**ADDENDUM NO. 1**

**CID 01-STILLHOUSE BRANCH WASTEWATER TREATMENT FACILITY  
IMPROVEMENTS**

**PROJECT NO.: 2-01590 | TWDB CWSRF NO. 73776**

**DATE OF ADDENDUM: MAY 24, 2023**

**YARD PIPING PROFILES - LINE D**

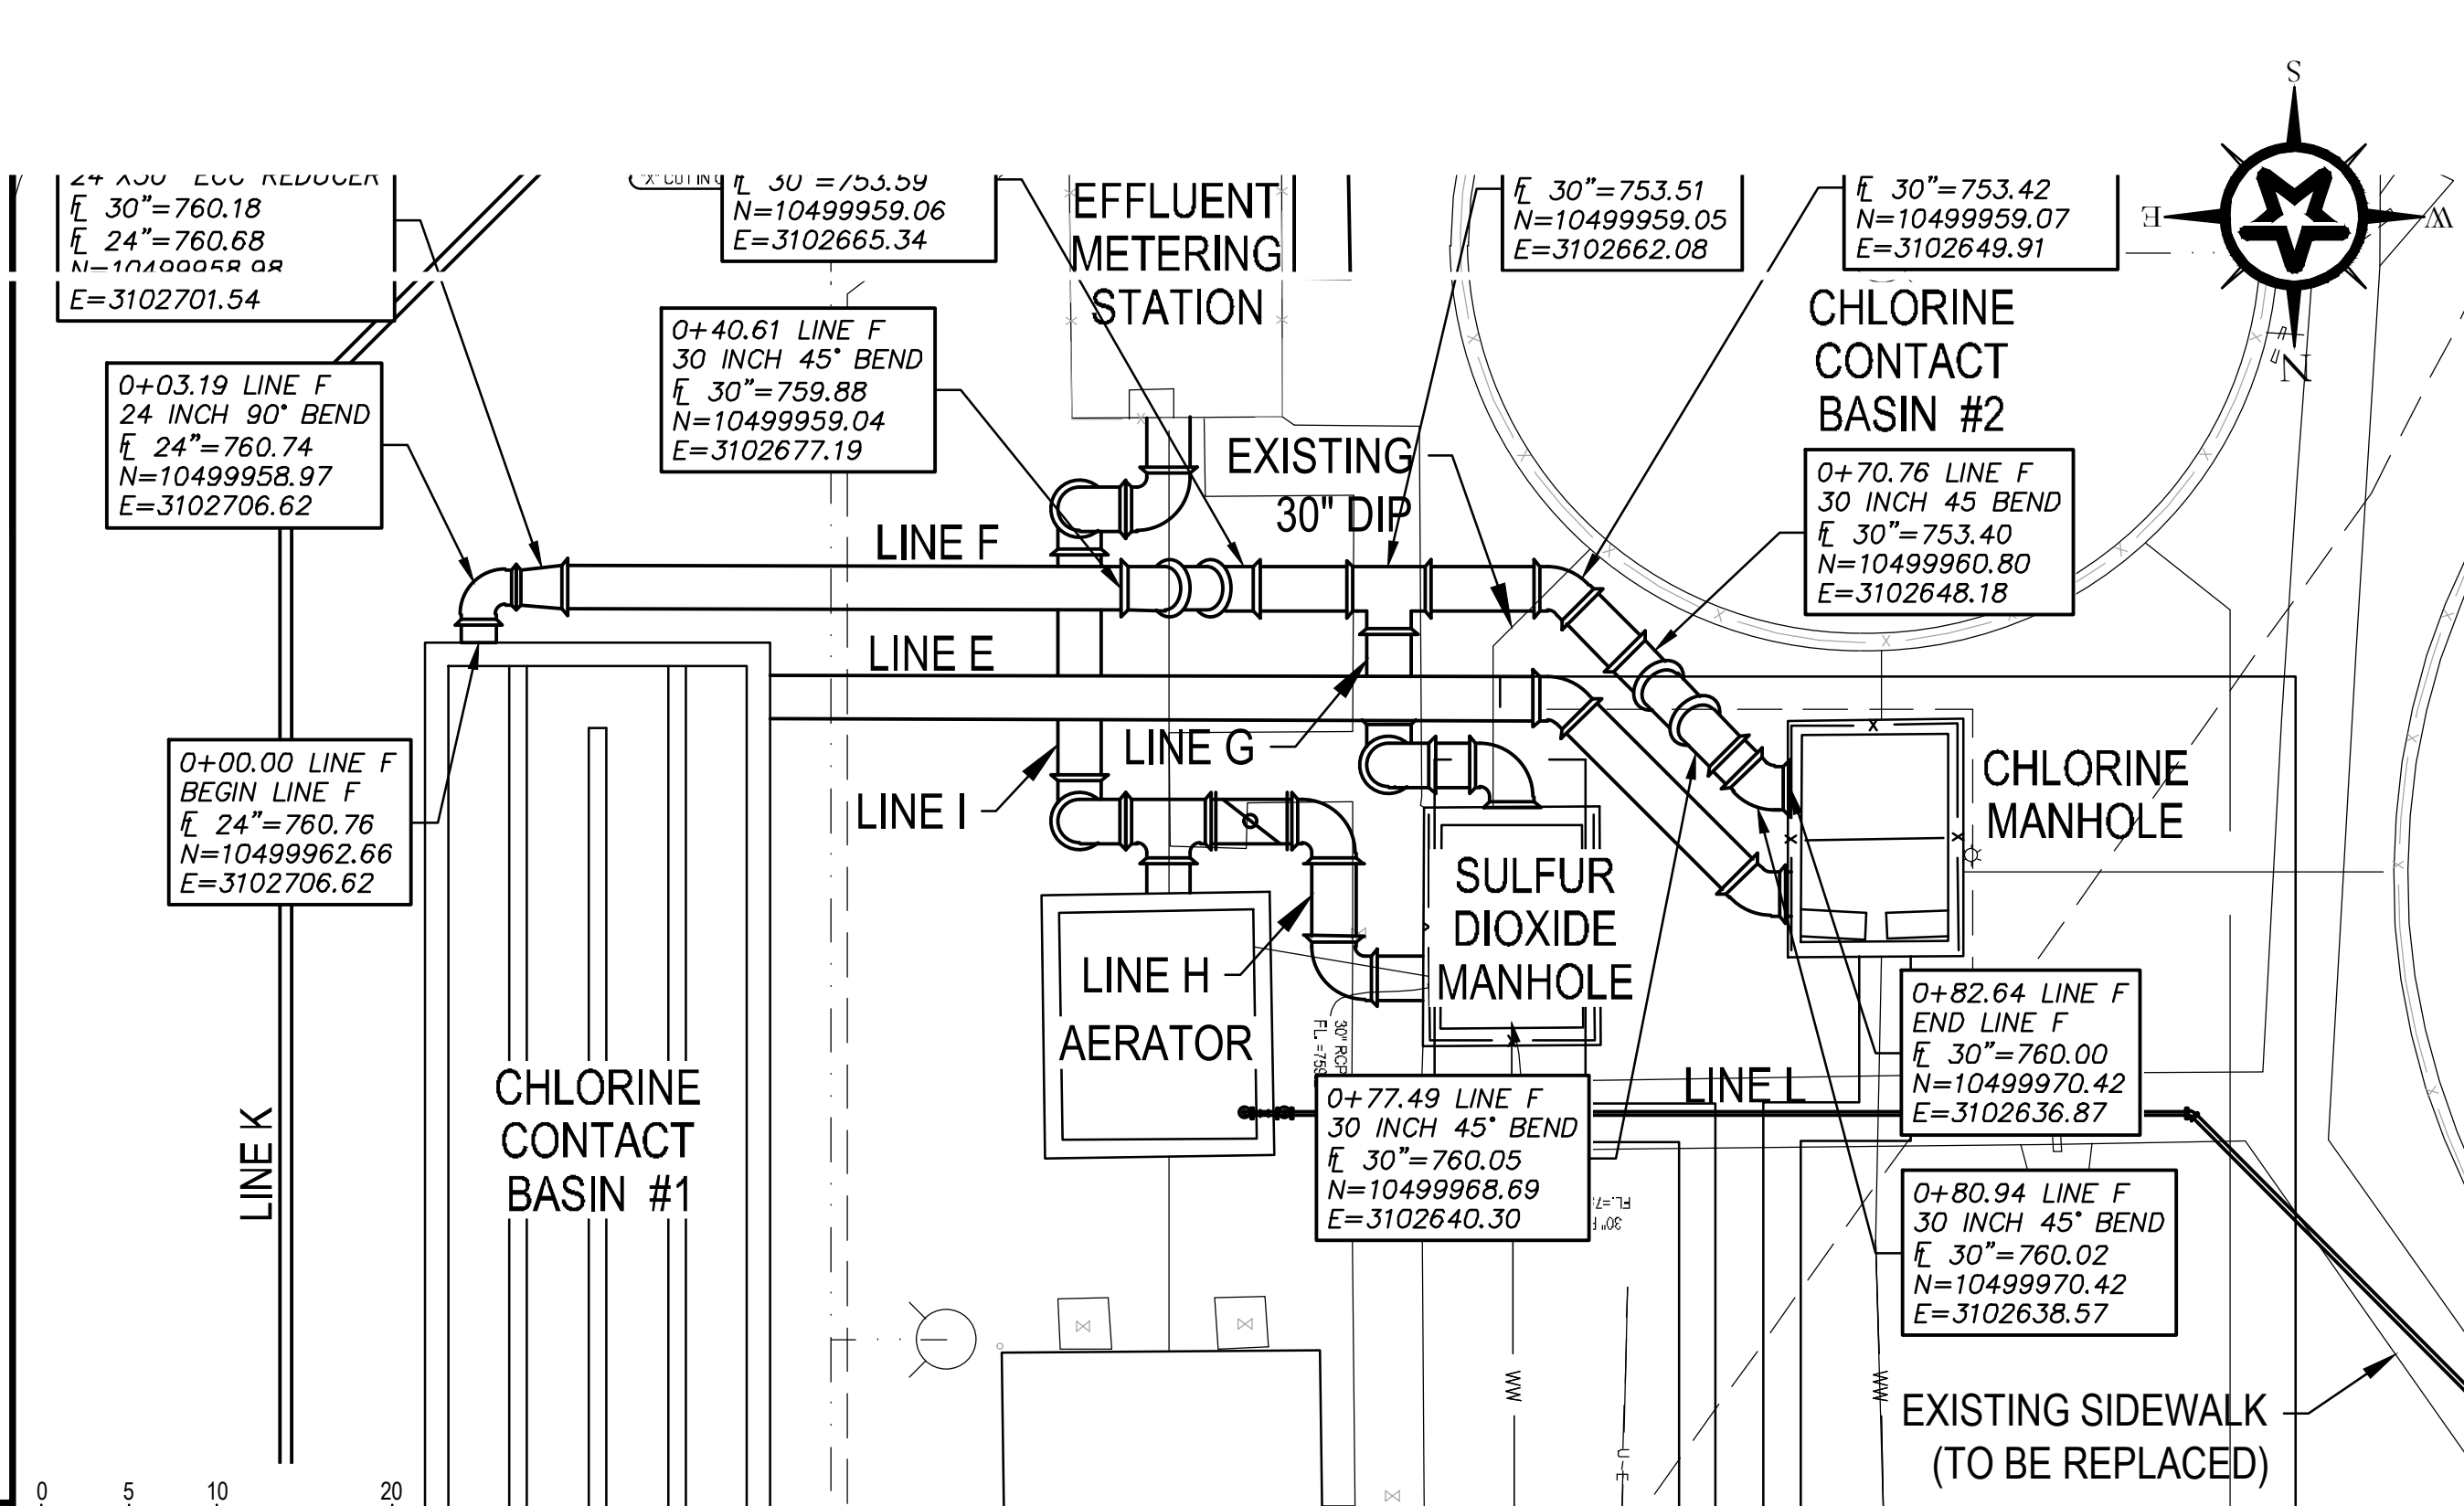
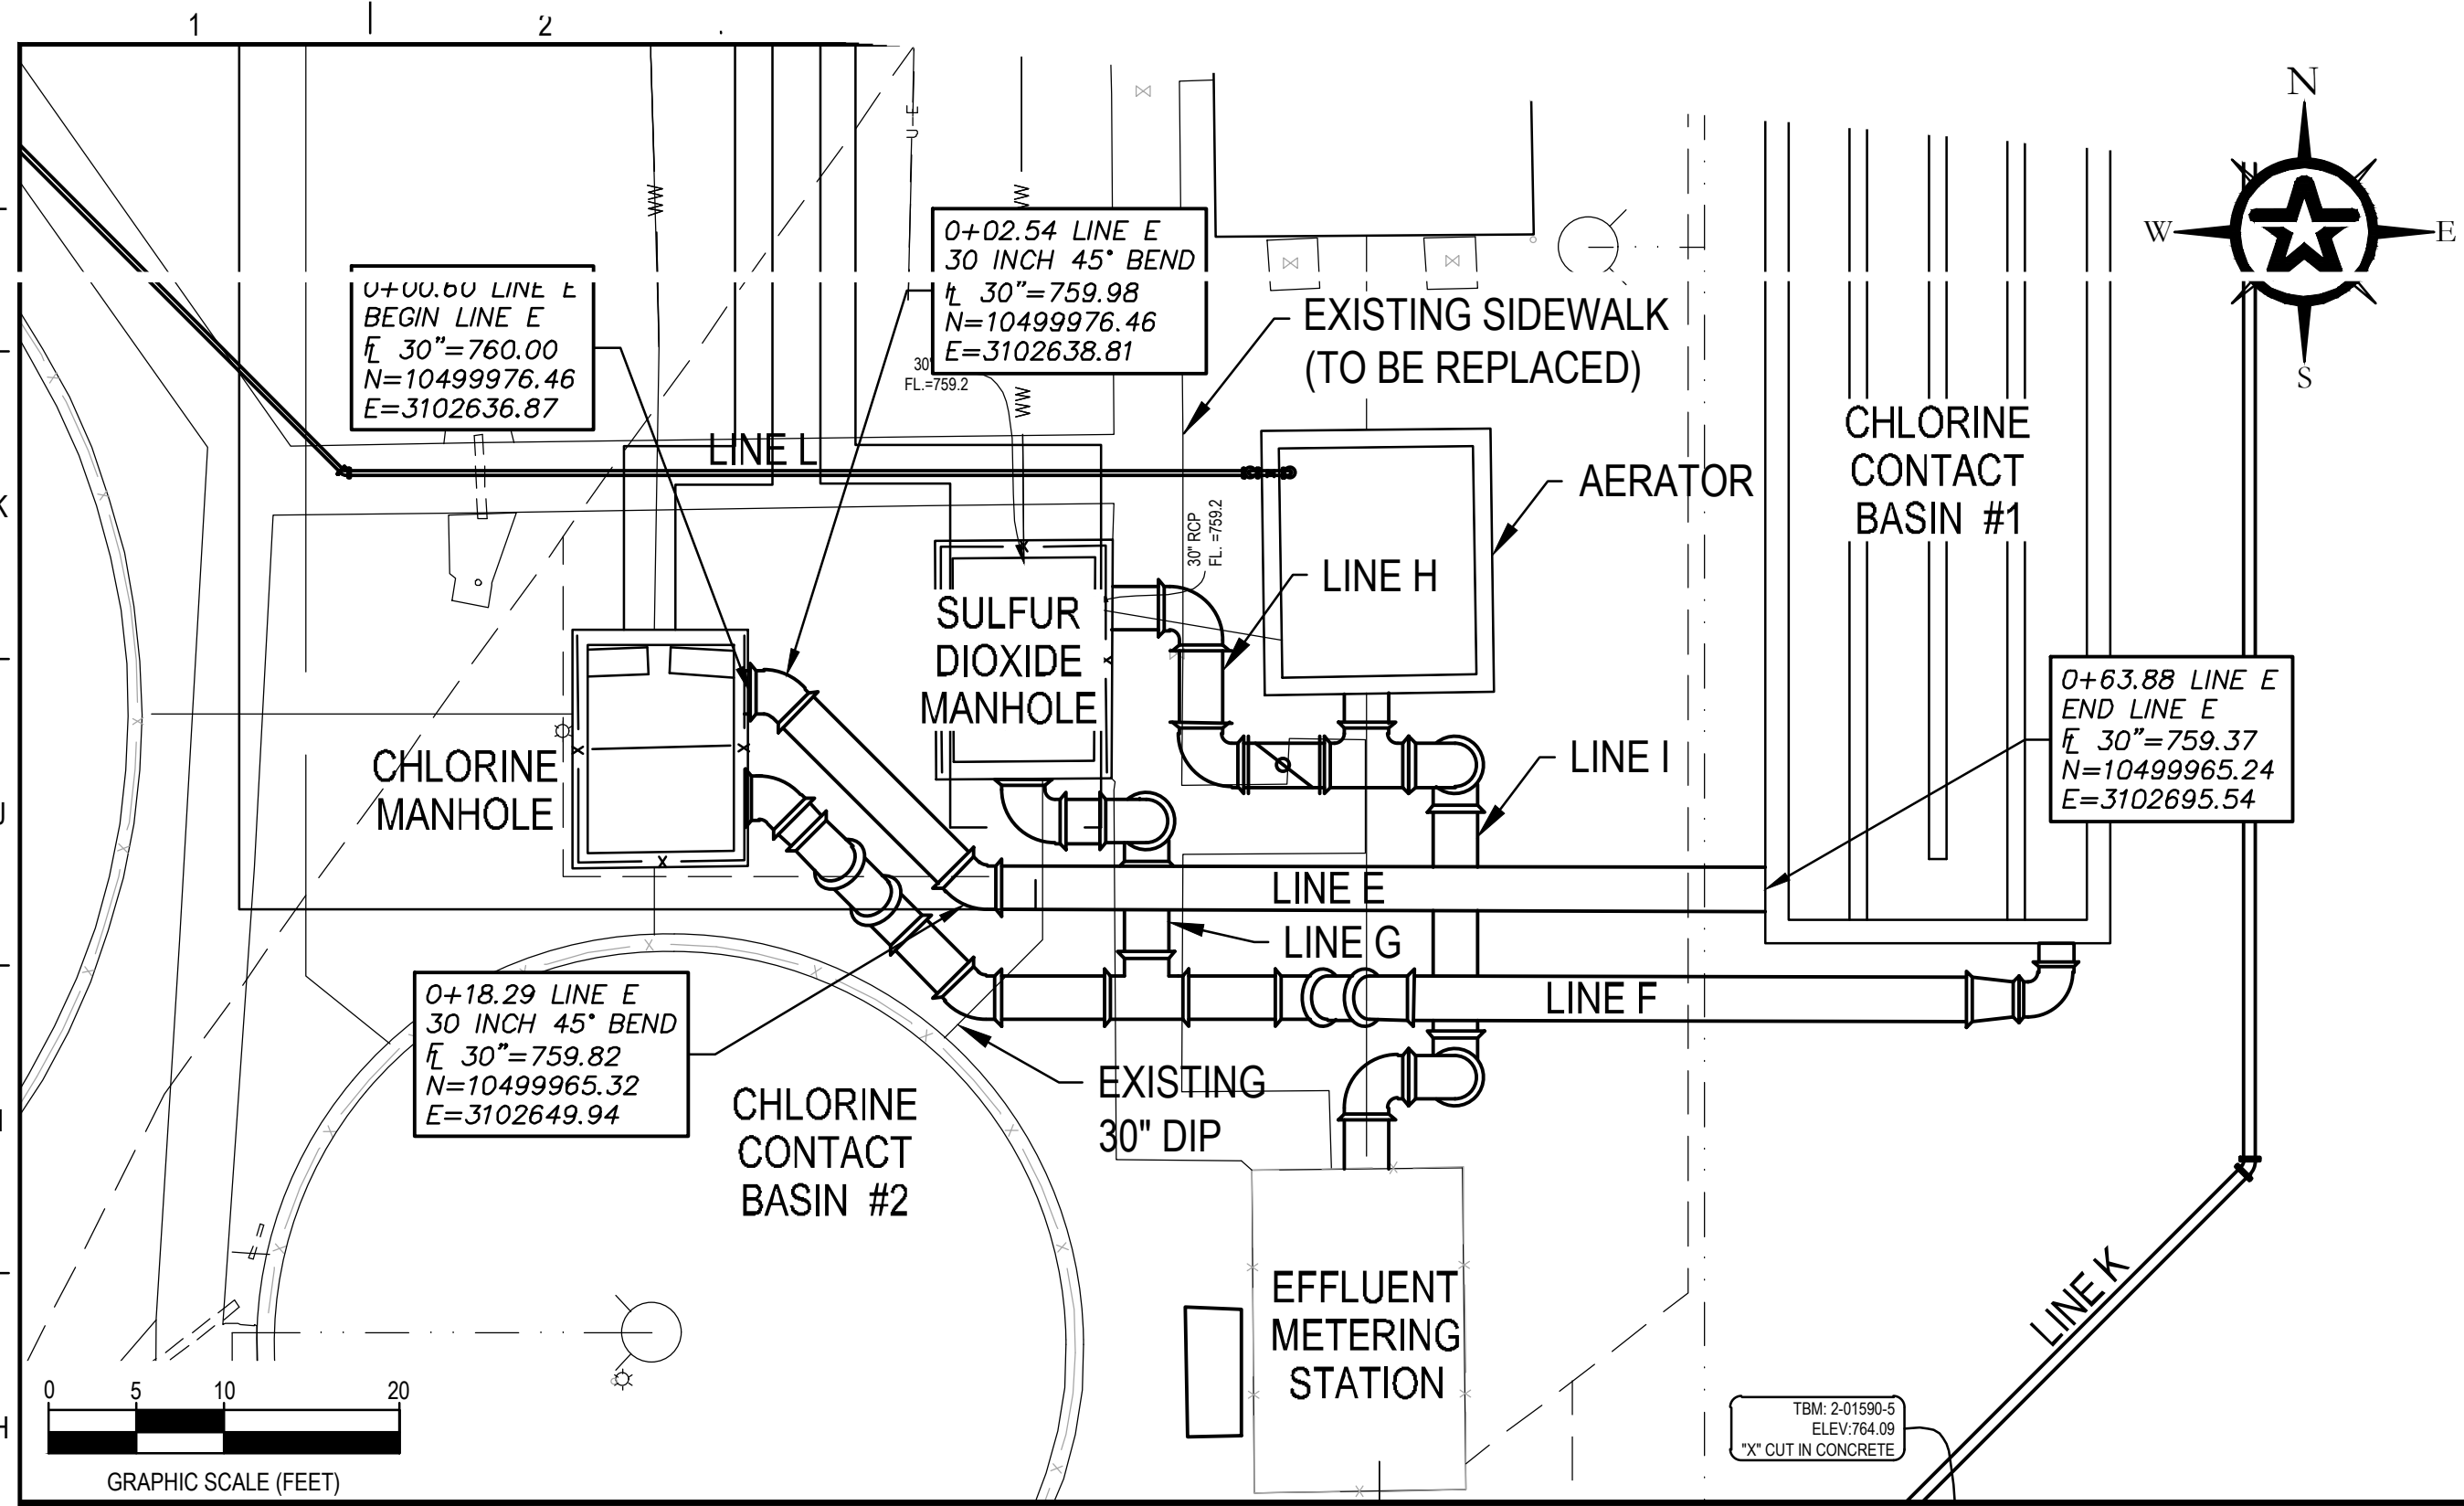
a. Sheets C-08 through C-17

REVISE yard piping to reflect the pipe labels on Sheet M-01 and Sheet M-02.
